St. Louis River/Interlake/Duluth Tar Site
Duluth, Minnesota

FEASIBILITY STUDY REVISED ADDENDUM 1

**FEASIBILITY STUDY
ADDENDUM No. 1
ST. LOUIS RIVER/INTERLAKE/DULUTH TAR SITE
SEDIMENT OPERABLE UNIT**

March 29, 2004

**Figure 2-1
Previous On-Site Storage Volume
Estimating Technique**

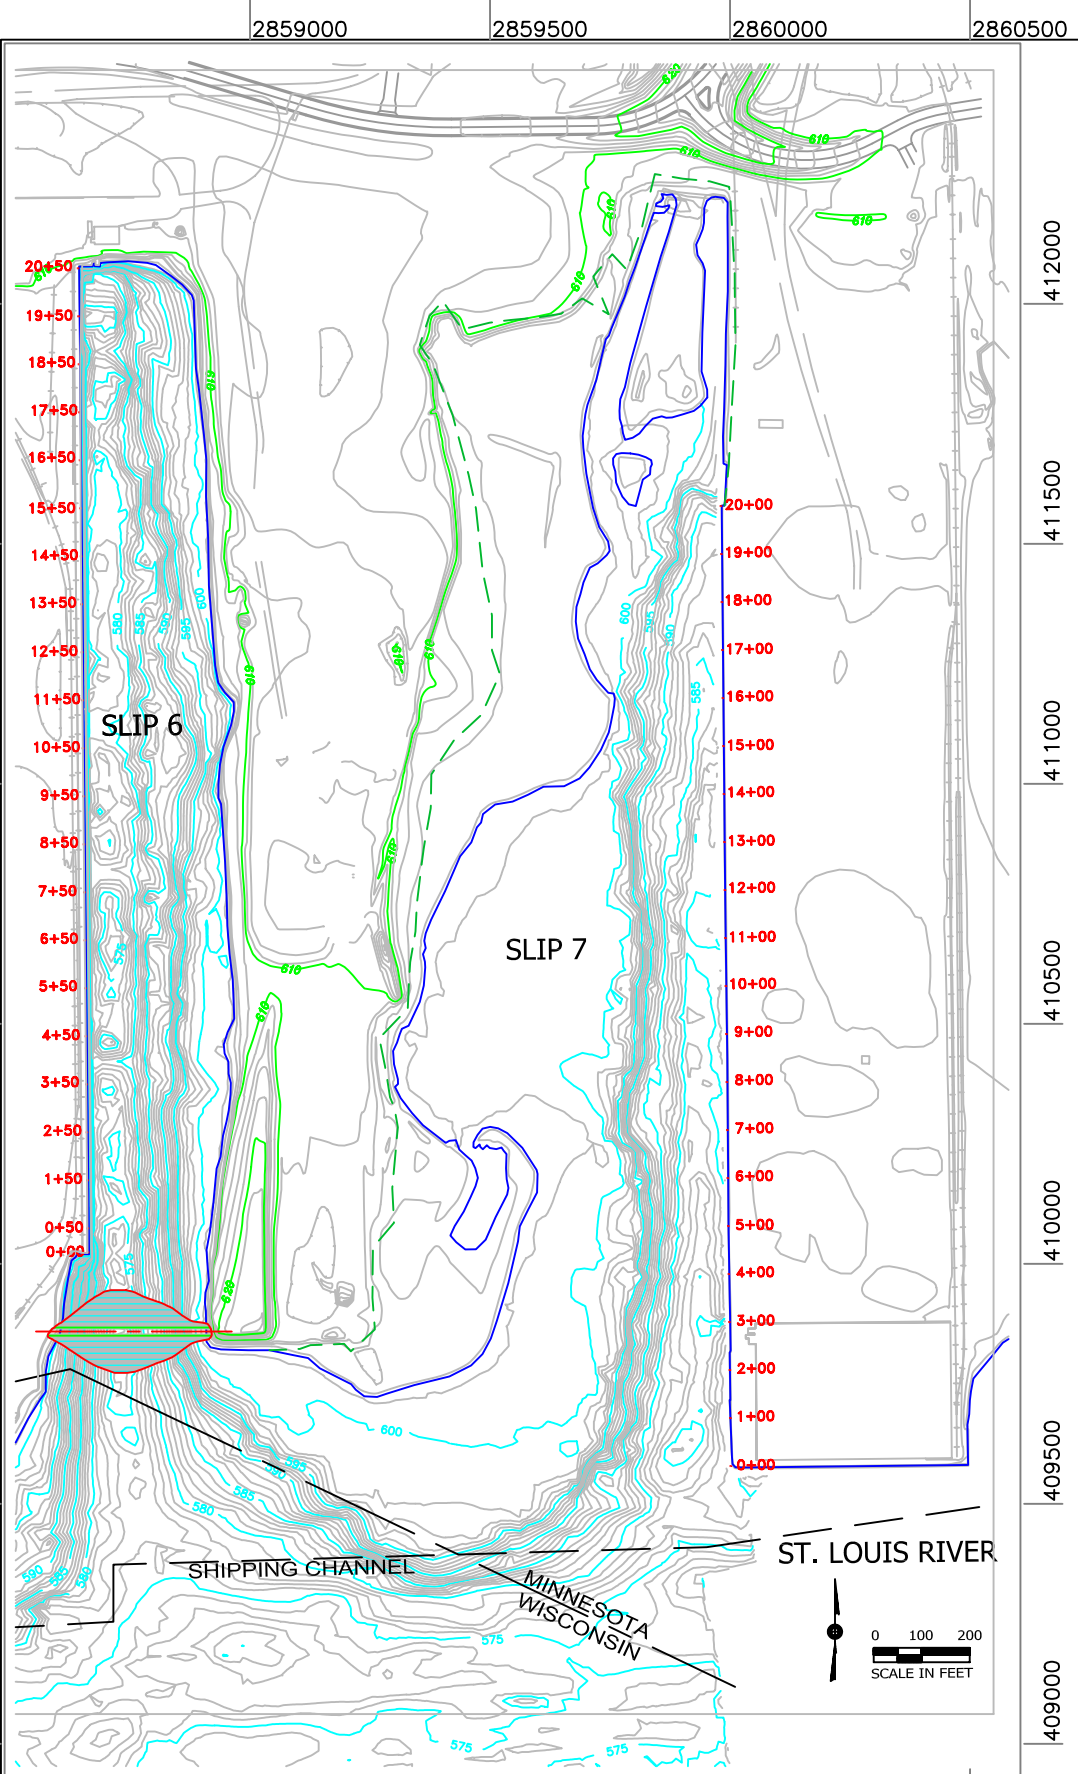
On-site disposal capacity in the deep portion of Slip 7 was approximated in Dredge/Cap Hybrid Alternative in the FS using a technique that was flexible enough to vary the quantities of various options. More detailed analysis indicates those calculations overestimated the available storage in the slip, necessitating a larger on-site disposal capacity—even to hold the previously estimated volume. The approximation assumed a minimally-sized disposal cell at the north end of the slip (located 1,500 feet north of the south end of the dock at Station 15+00), and then estimated how much additional volume was gained for each foot the centerline of the containment dike moved south. This estimate was based on the premises that: (1) the cross section of the deep area was fairly constant, and (2) that the cross section that was used to move north and south to subtract or gain volume was representative. As illustrated in **Figure 2-1** both assumptions were incorrect. The cross section is neither constant nor represented accurately with the “original average section.” These errors resulted in an overestimate of the actual volume of available storage, especially in a CAD whose area is limited to the shallower north end as shown in the FS. The erroneous estimated volume from the FS when filling the CAD areas north of Station 8+00 to elevation 601 is shown on **Figure 2-3** with a diamond shape.

The Original "Average" Section was used to project the volume between stations 15+00 and 8+00. The "Average" section, being too deep and too wide, was not average. This caused an overestimate of the available capacity of a CAD ending at Station 8+00.

Original Average Section moved North & South, creating a prism volume matched to the estimated Storage needs.

Figure 2-3
Summary of Slip 6 CAD On-Site Storage Capacity
SLRIDT Site, Duluth, MN

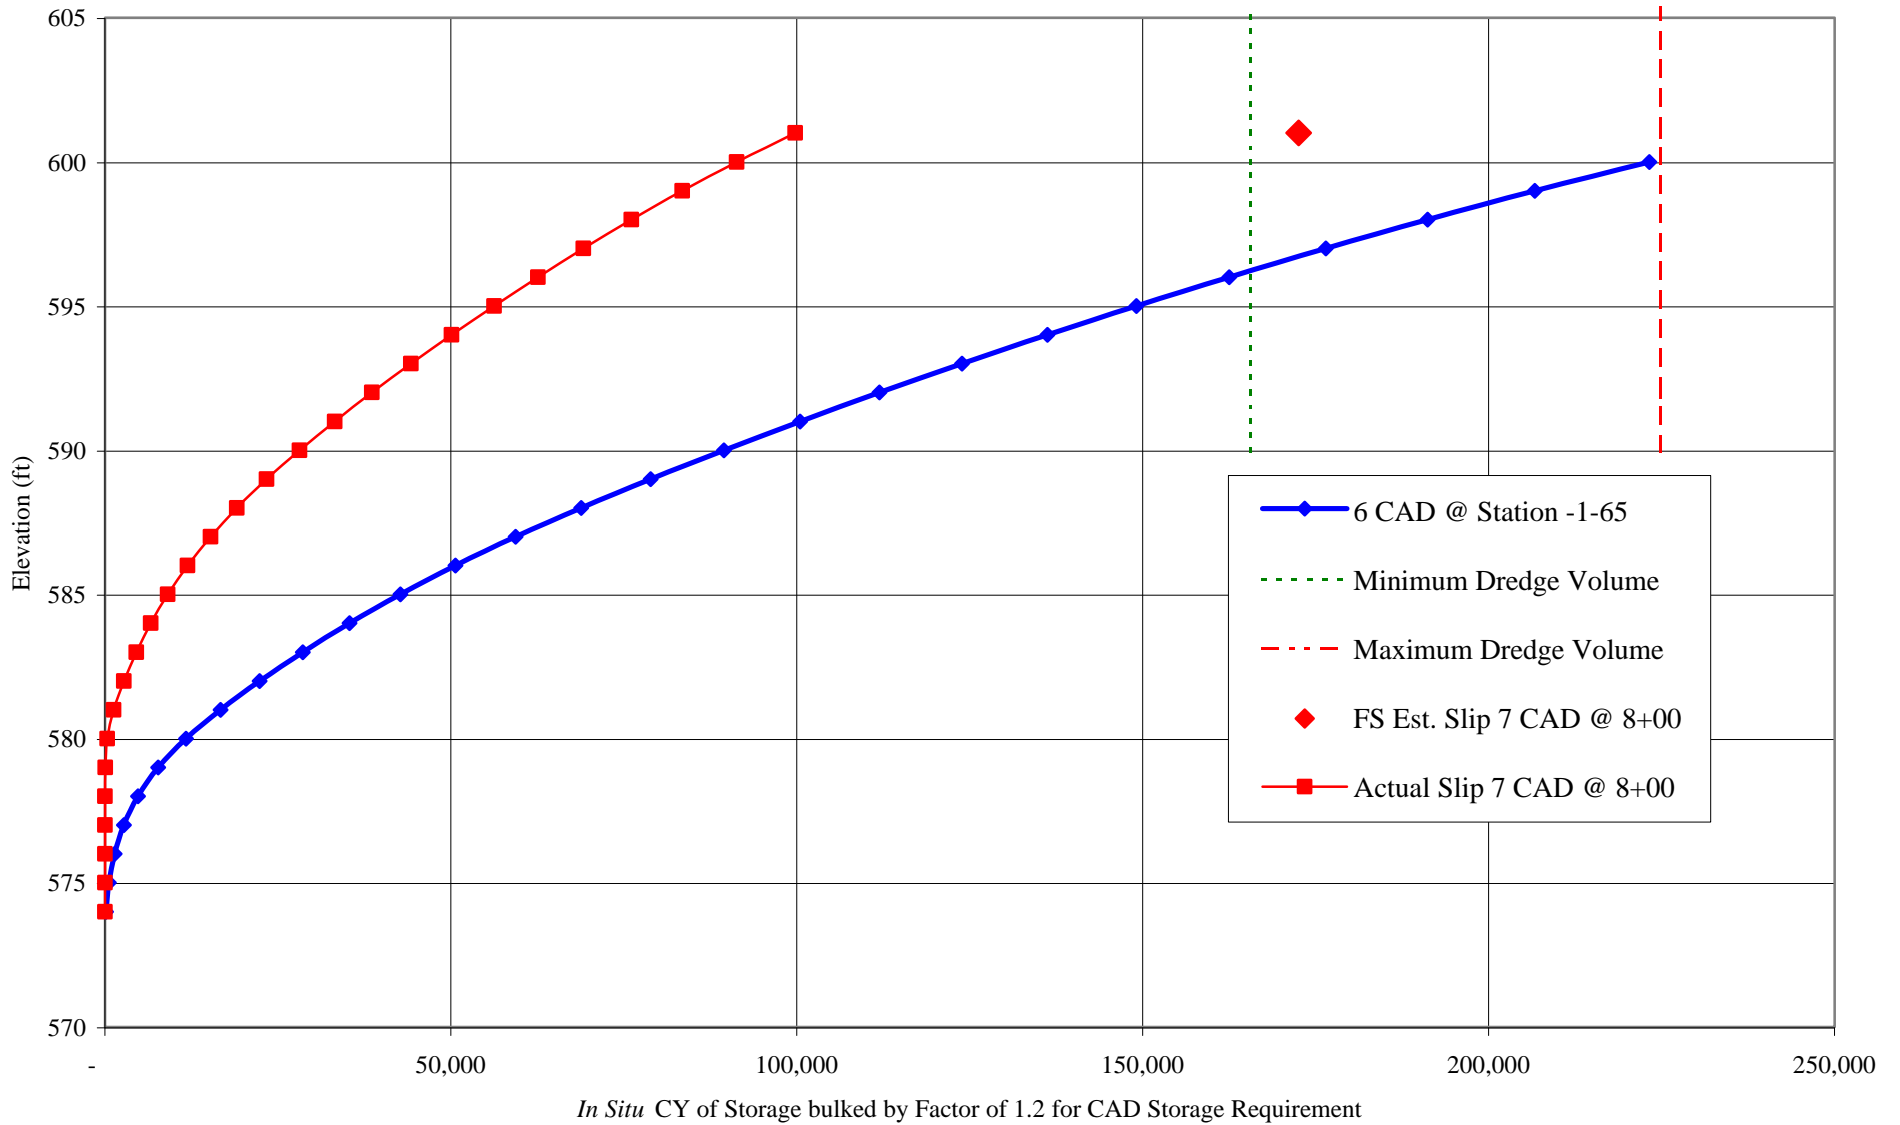
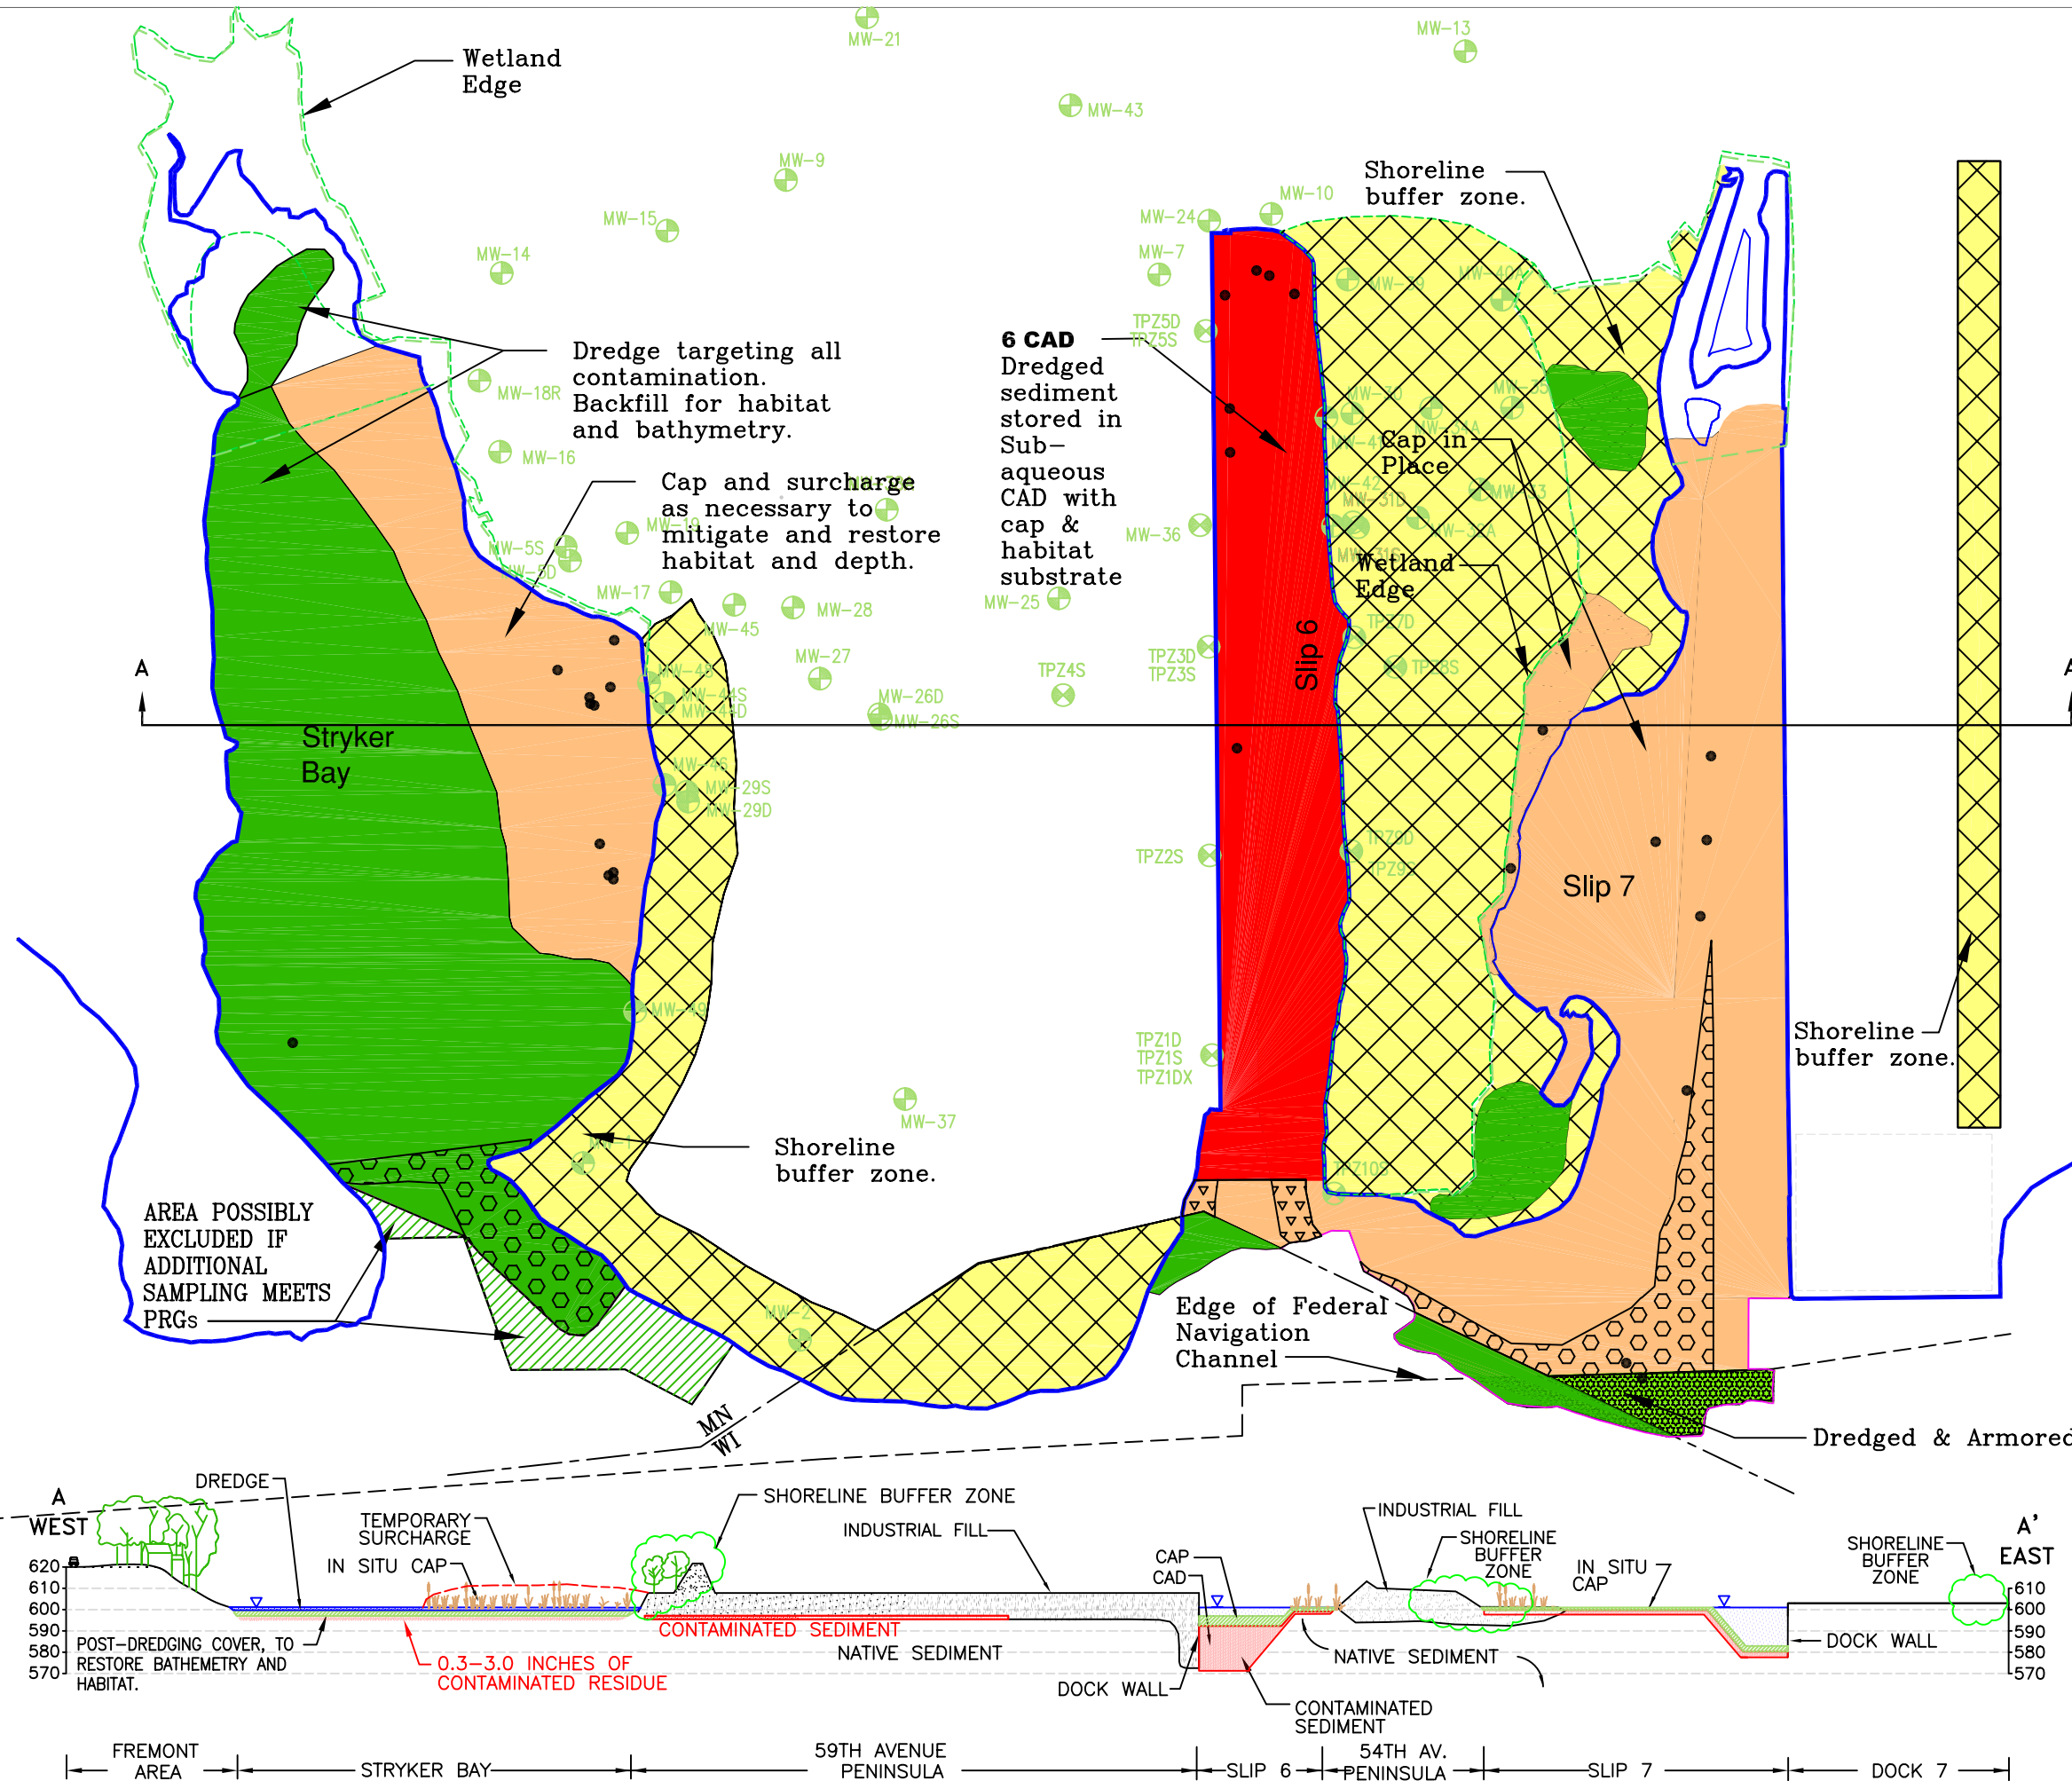
The results are shown in **Figure 2-3**. While the erroneous volume estimate in the FS showed a capacity within the target volume range developed for this Addendum, the actual volume is about 72,000 *in situ* cubic yards less. Comparing the actual available storage capacity of a Slip 7 CAD at Station 8+00 to the minimum and maximum range of projected dredge volumes, a substantial shortfall is evident, ranging from a minimum of 66,000 *in situ* cubic yards, to a maximum of 125,000 *in situ* cubic yards. To store those additional yards in the same CAD footprint would raise the sediment to elevations ranging from 609 to 617 feet, compared to a water level averaging 601.8 feet. Dikes would be four to six feet higher. The large internal head of water that such a facility would create would substantially change the operating conditions and possibly the safety of the operation. After completion, it would remain an upland mound. Similarly, because of structural limitations in the adjacent dock wall, slope stability issues on the western side and the presence of a thick layer of contamination within the footprint, overexcavating clean material from the base of the CAD is infeasible.

The centerline of the dike is estimated to be located about 165 feet south of the south end of the dock wall Station 0+00. The available storage north of that dike is shown in Figure 2-3. The Elevation/Volume Curve indicates that the Slip 6 CAD is deeper and larger than the previous Slip 7 CAD, and can store the expected volumes when filled to an elevation ranging from 596 to 600. During design, dredge volumes and CAD design details would continue to be evaluated.

FIGURE 3-2
DREDGE/OFF-SITE DISPOSAL

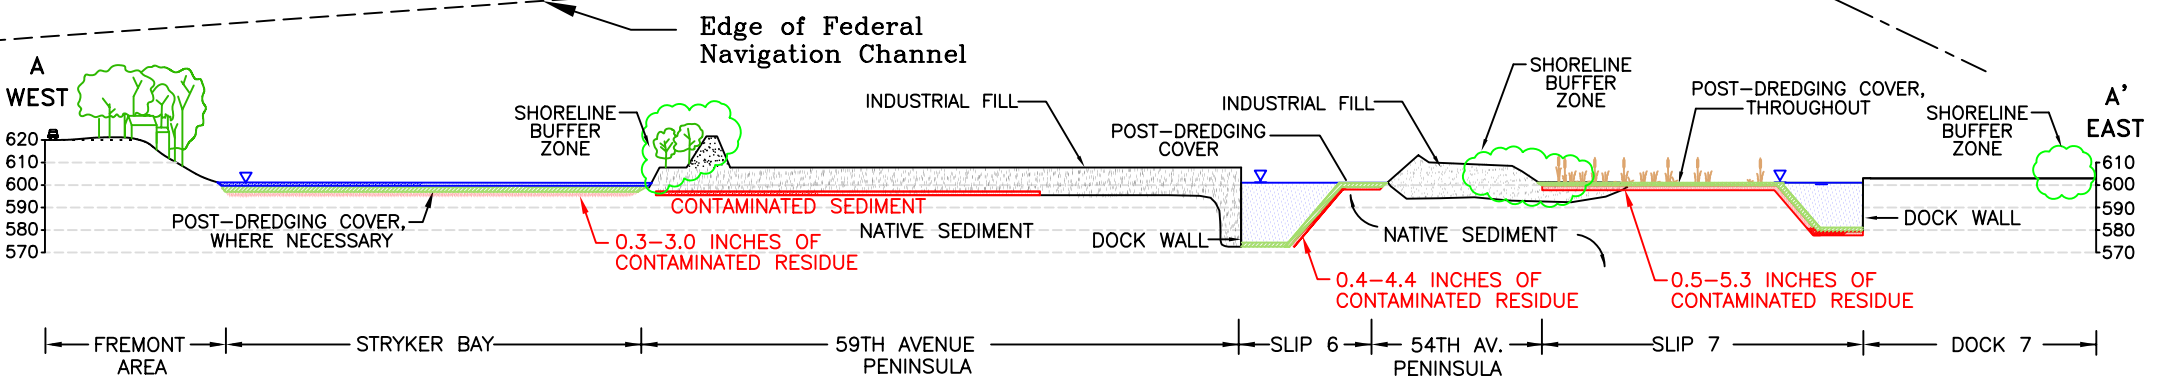
The expected dredge volume has increased from 495,000 up to 501,000 to 609,000 *in situ* cubic yards (1 to 23 percent). Areas to be remediated in the on-shore wetlands of Slip 7 have been updated to reflect the results of additional sampling since the FS. Otherwise, the physical dimensions of the alternative are unchanged as shown in **Figure 3-2**.
